ADDENDUM NO. 1

Date: July 1st, 2026
Project Name: Southwest Trail: Hilario Springs Rd. - Baseline Rd. (S)
Owner: Pulaski County
Garver Project No. 17019260

DRAWING NUMBER
C-010

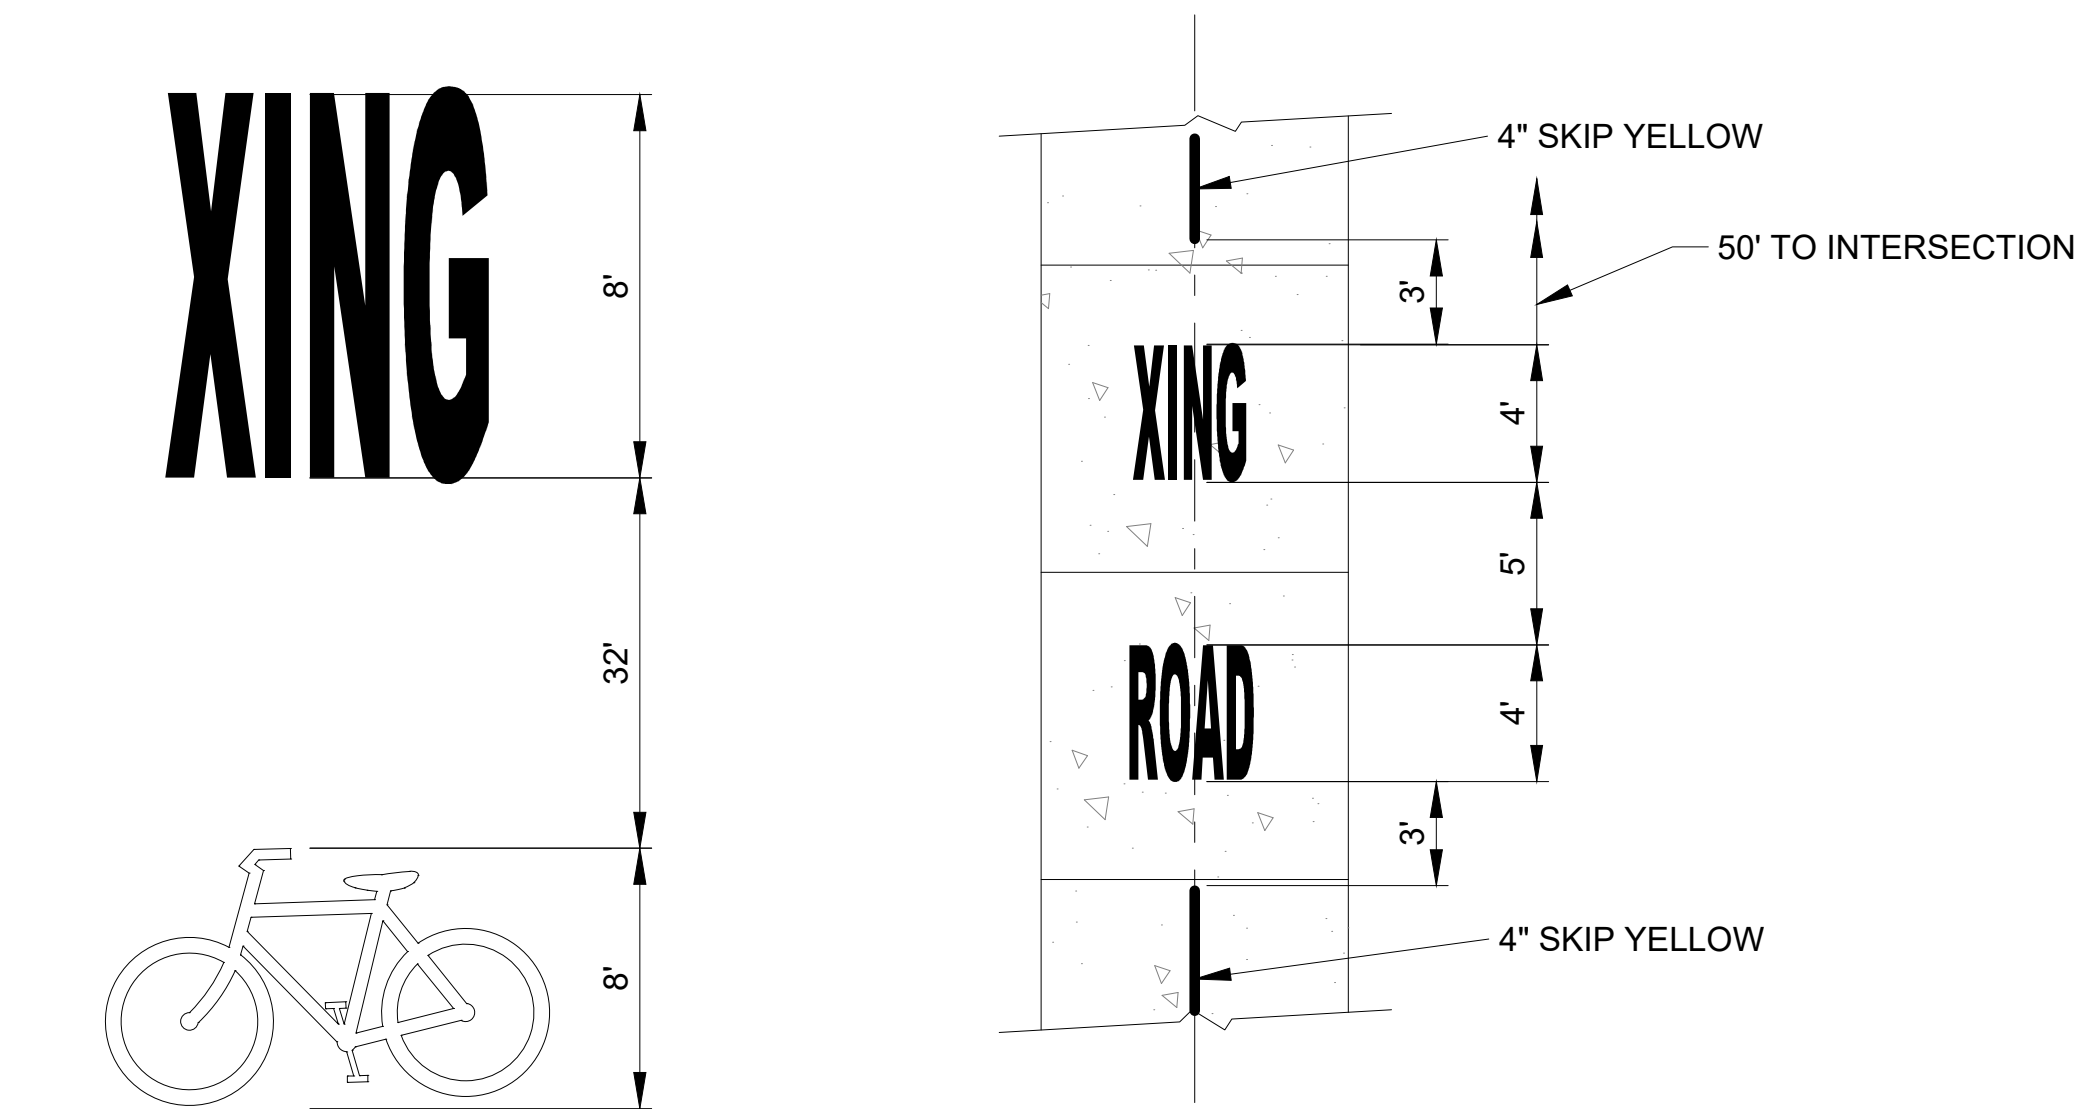
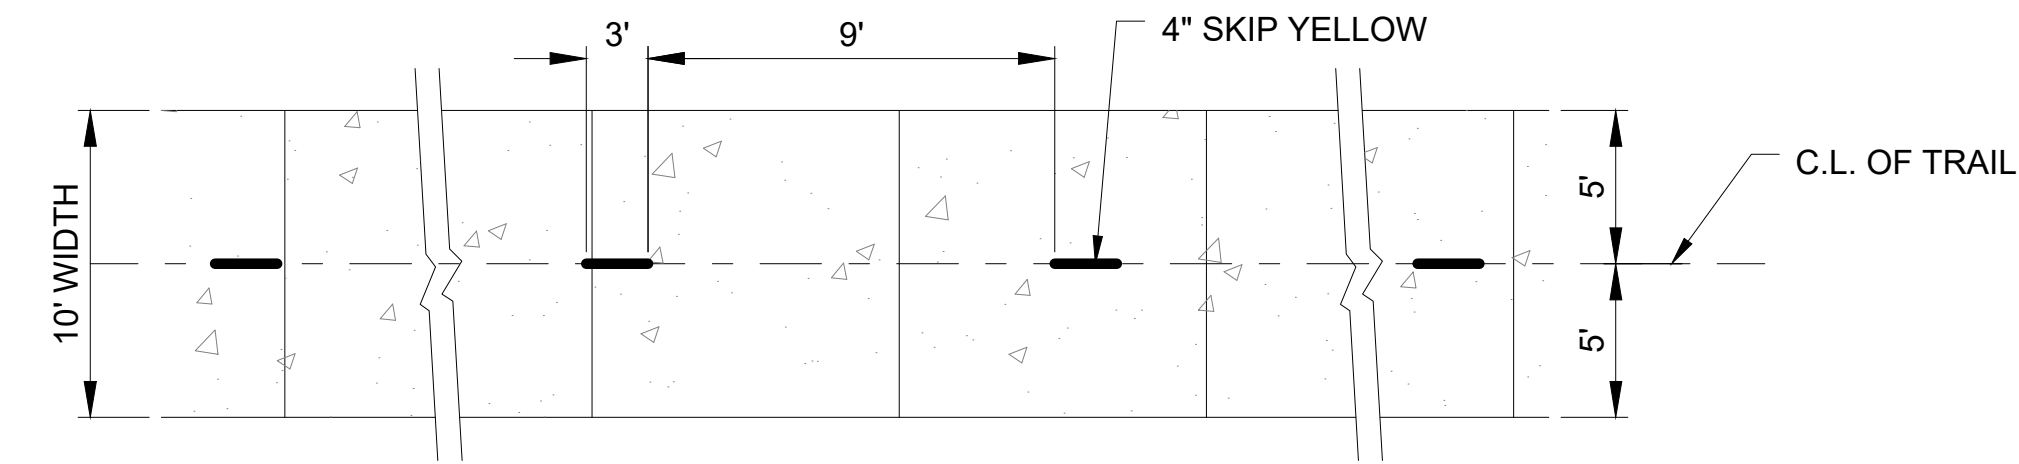
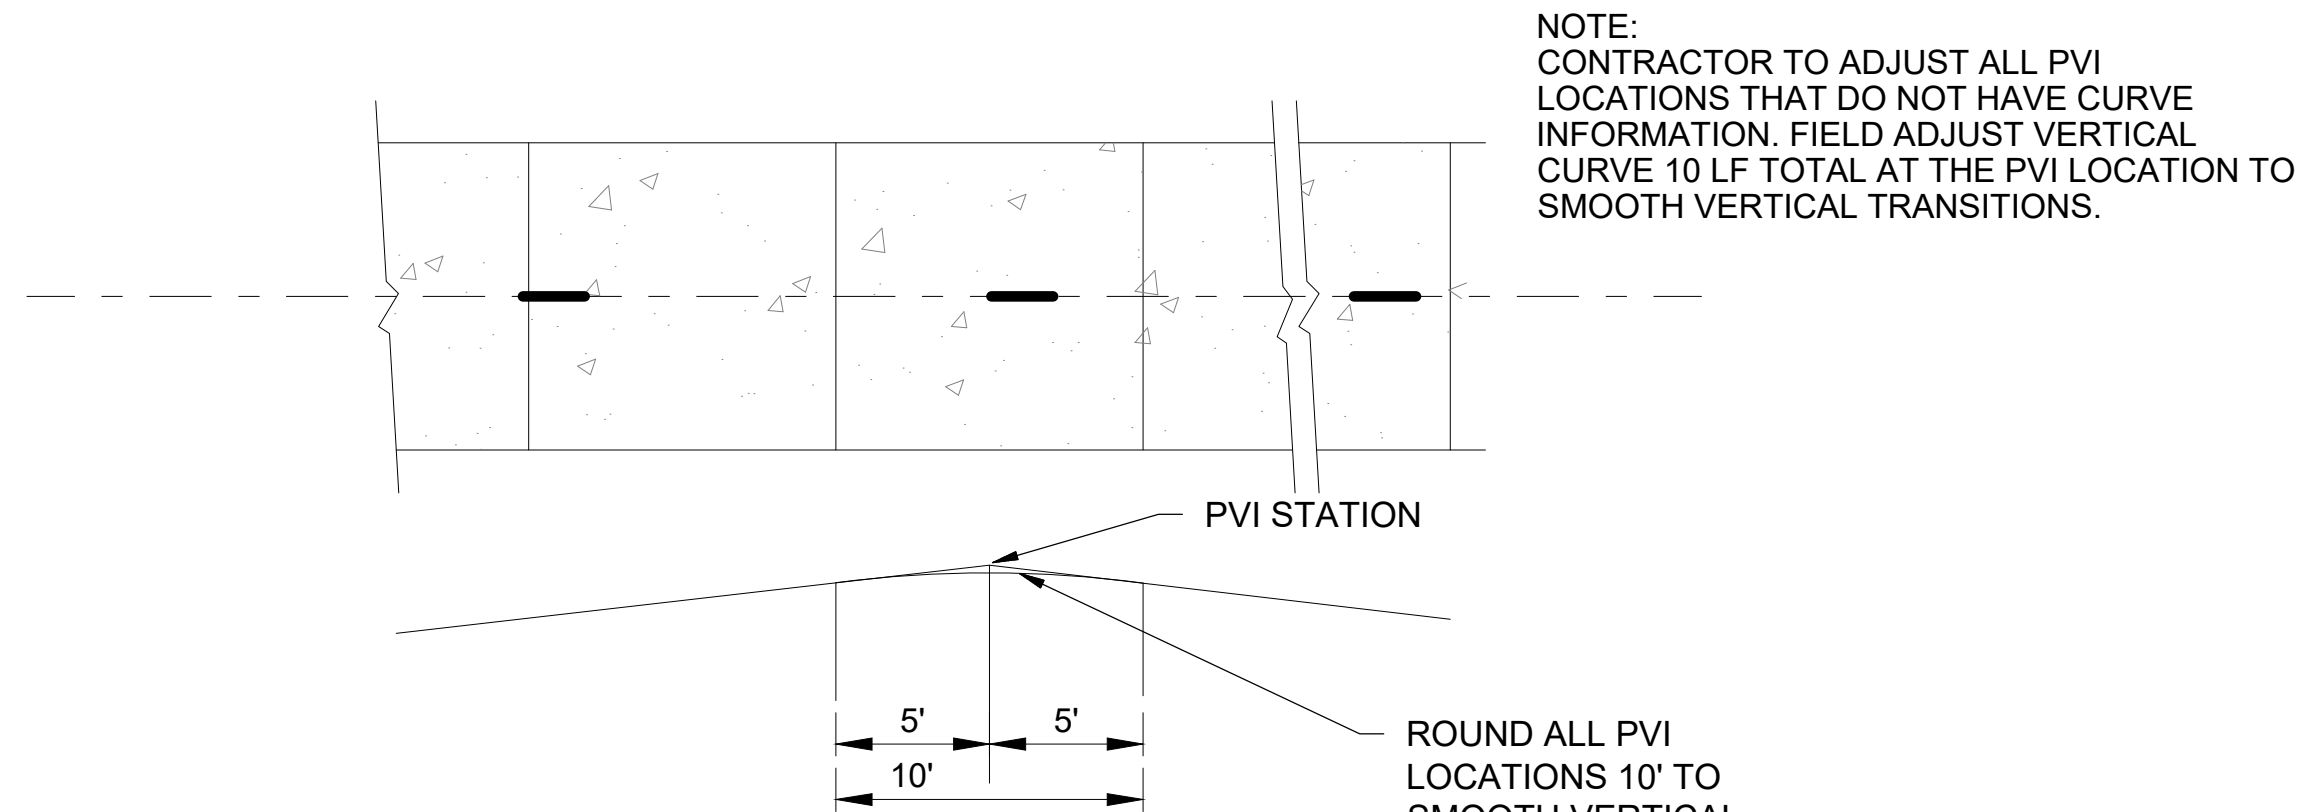
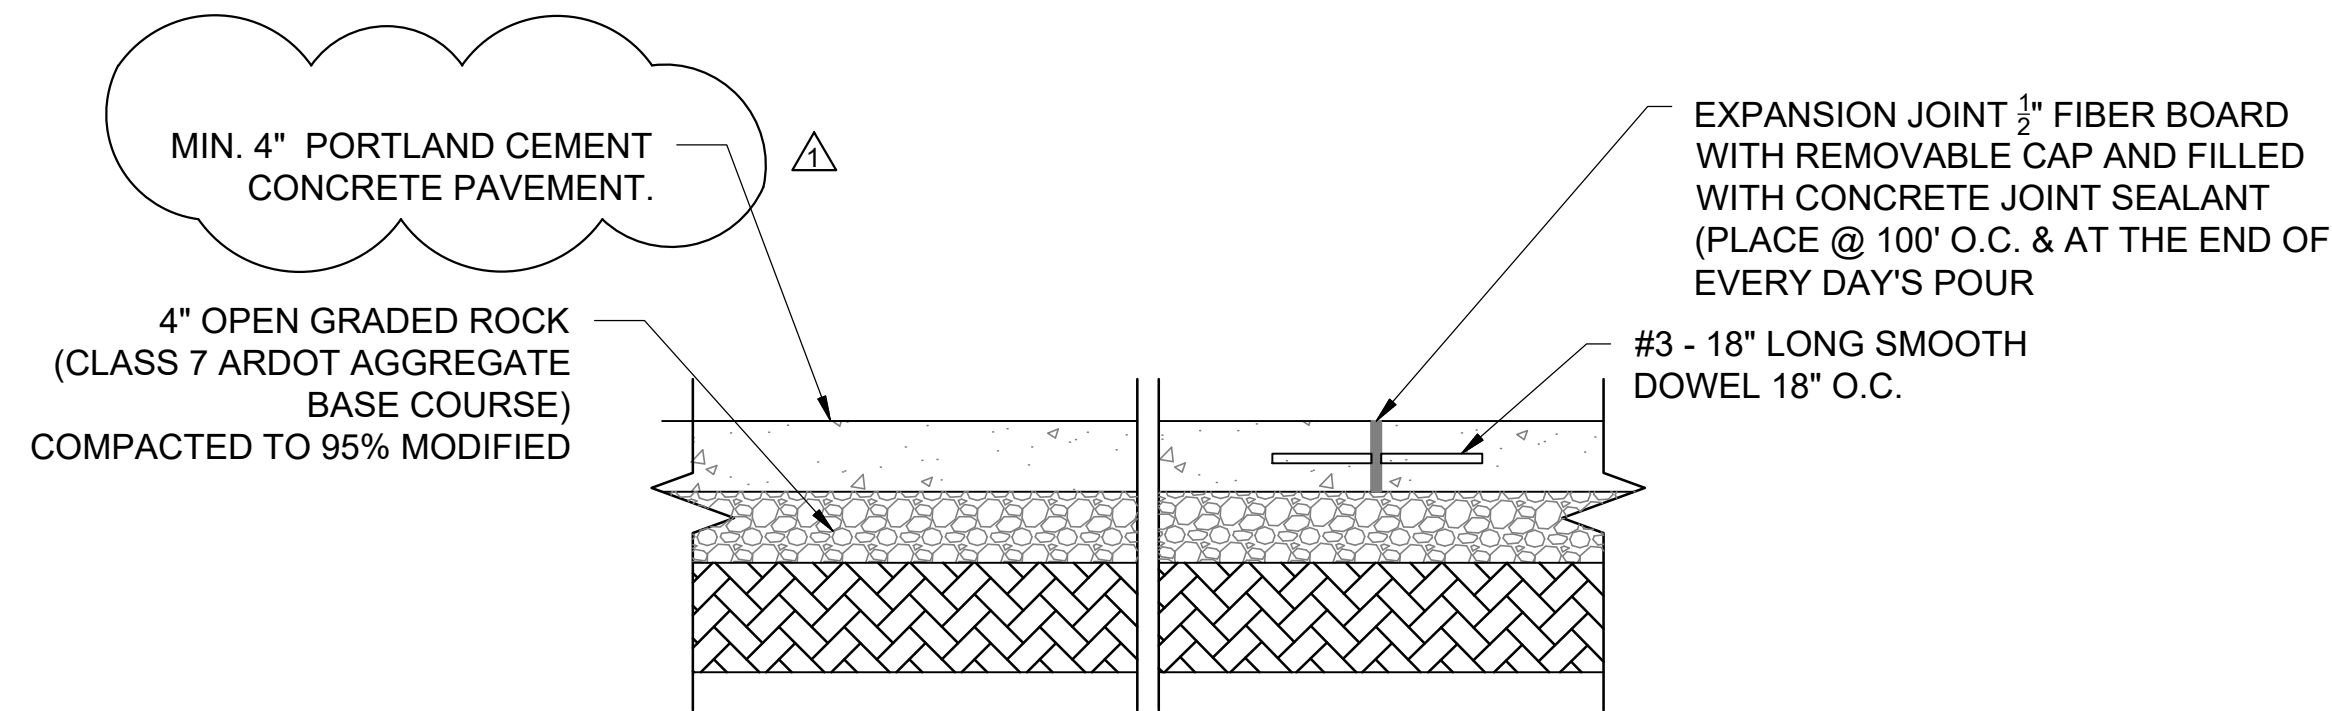
1. Drawings C-010 SPECIAL DETAILS was revised to correct the proposed Concrete Pavement Thickness from 5" to 4".

BY	AMW		
DESCRIPTION	CORRECTED CONCRETE THICKNESS FROM 5" TO 4"		
DATE	7/1/2026		
REV.

- a. **Remove drawings C-010 Special Details in their entirety, and replace with C-010 Special Details (rev. 2026-07-01), attached hereto.**
